Date: April 15, 2021  
To: Brenda Hall, City Clerk  
From: Rachel Croft, Staff Engineer *RC*  
Subject: Consent to Encroach 2021-10  
(4405 Cannon Dr – Block 1, Lot 15, Carrington Addition, Section 6)

# 4405 Cannon Drive

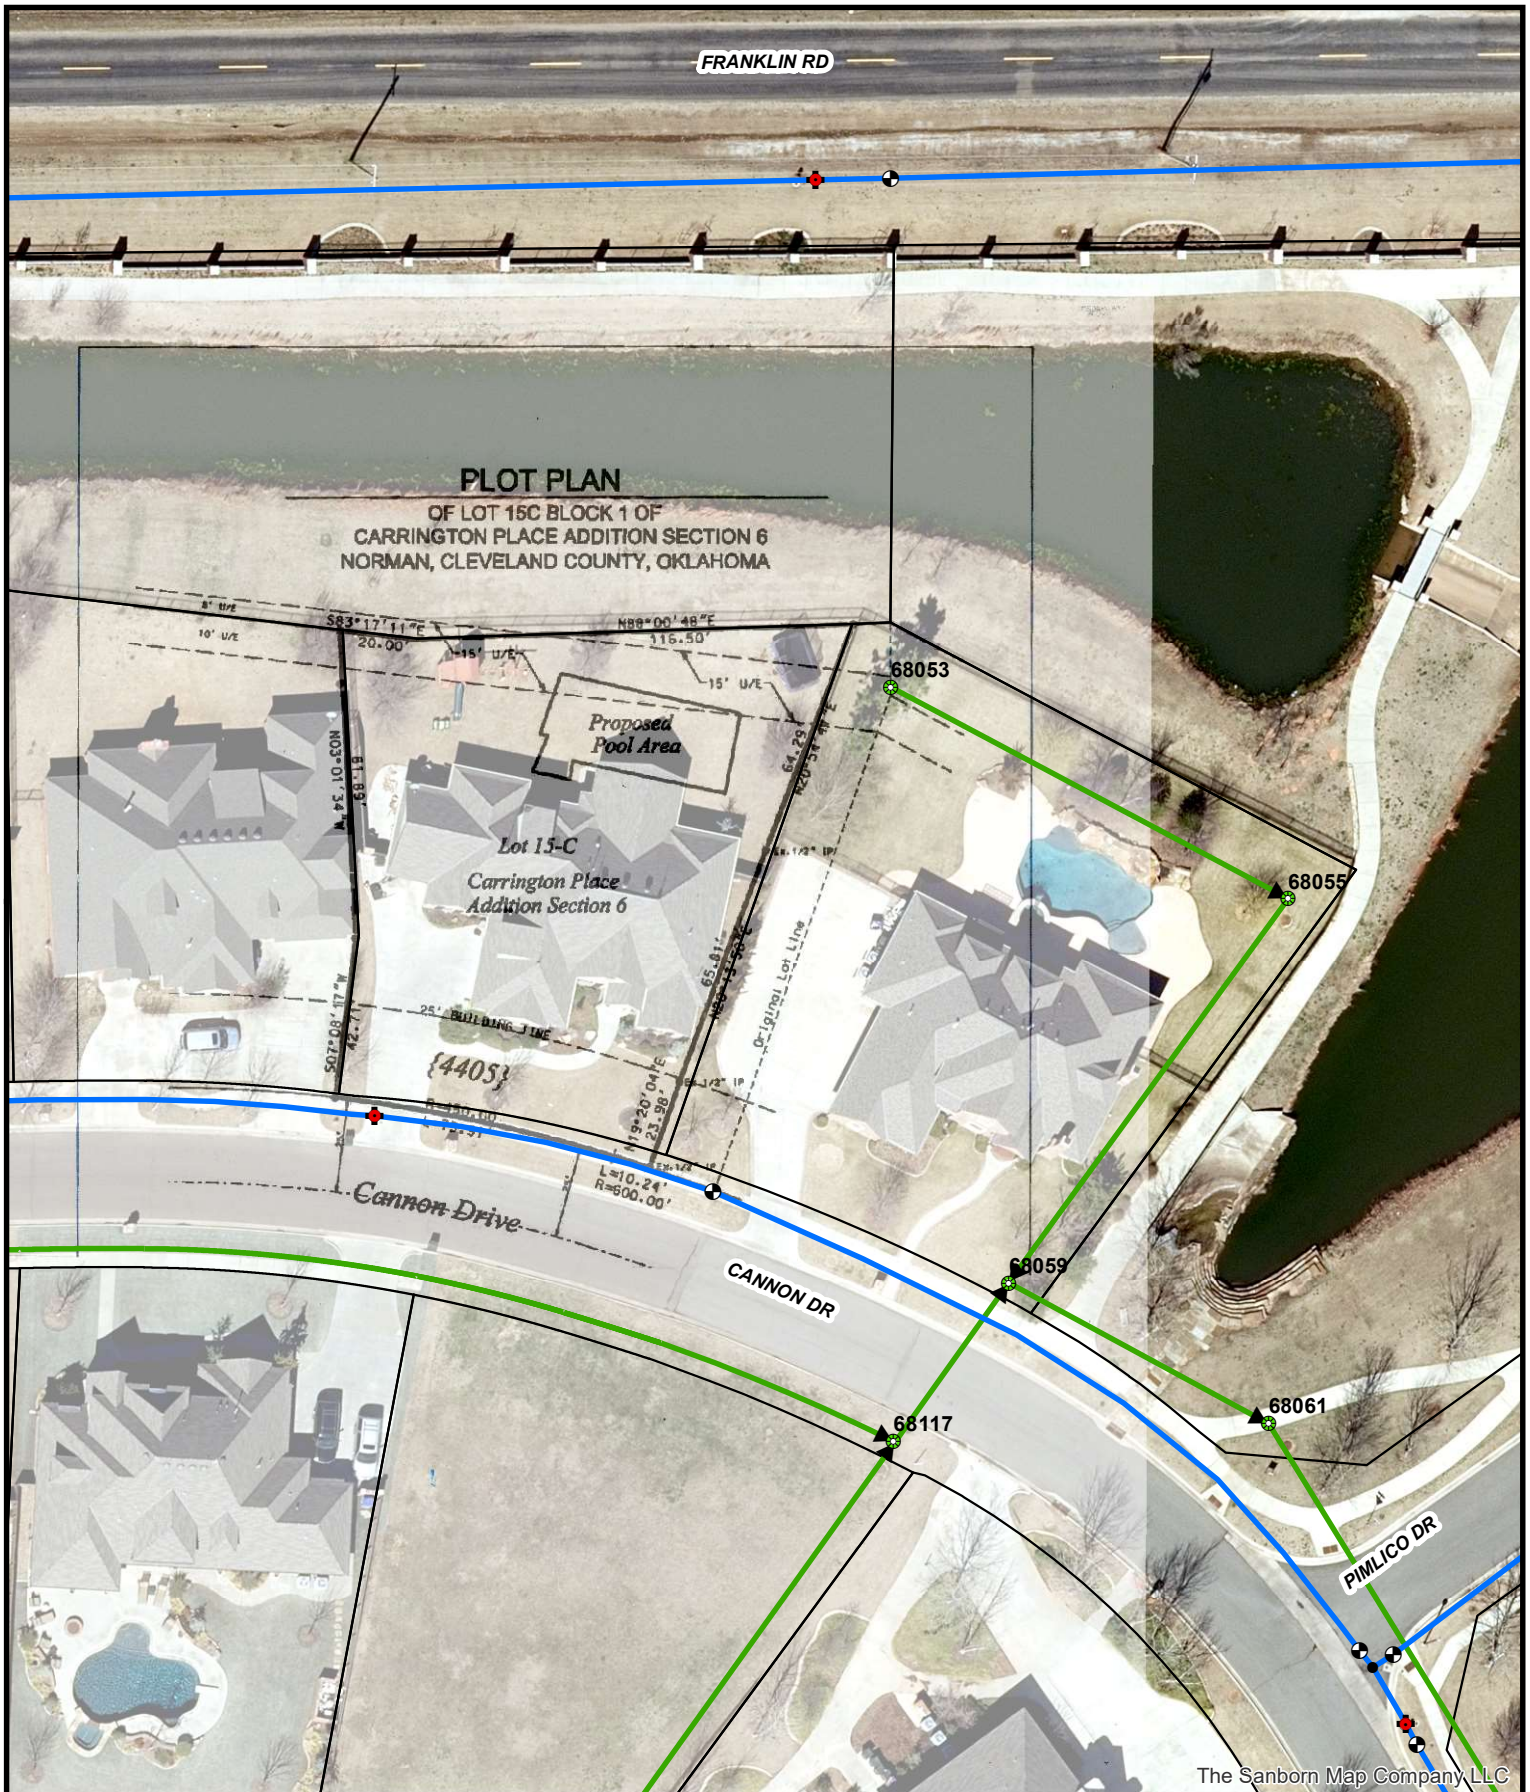
An existing platted utility easement lies along the north side of the subject property. The applicant proposes to encroach into this easement with a pool.

An existing 8-inch waterline is located within the existing right-of-way for Cannon Drive next to the building line of the property and a 12-inch sanitary sewer line is located within the existing right-of-way for Cannon Drive on the opposite side of the waterline. There is a sewer manhole and sewer line in the utility easement on the north side of the property to the east, but subdivision plans show the subject property is tied into the sewer line on Cannon Drive. The encroachment is approximately 5 feet into the easement at its maximum width with a length of about 50 feet. It lies about 120 feet from the waterline and 167 feet from the sewer line.

The Utilities Authority objects to all encroachments on utility easements. However, if the applicant agrees to the following requirements with consent document filed of record on the property for the duration that the private improvements and the encroachment are in place, NUA staff will not oppose a recommendation for approval:

1. The property owner will be responsible for the cost to repair any damages to the City's utilities caused by any excavation or other construction activities conducted by the property owner or his agents.
2. The property owner will be responsible for the cost the City incurs to remove any improvements or structure if needed to maintain or repair NUA facilities.
3. The property owner will be responsible for the cost to repair or replace any improvements or structure after such repairs.
4. The property owner will waive and release any claims against the City for any damages to the residence and related improvements caused by failure or repair and maintenance of the City's utilities within the easement area.
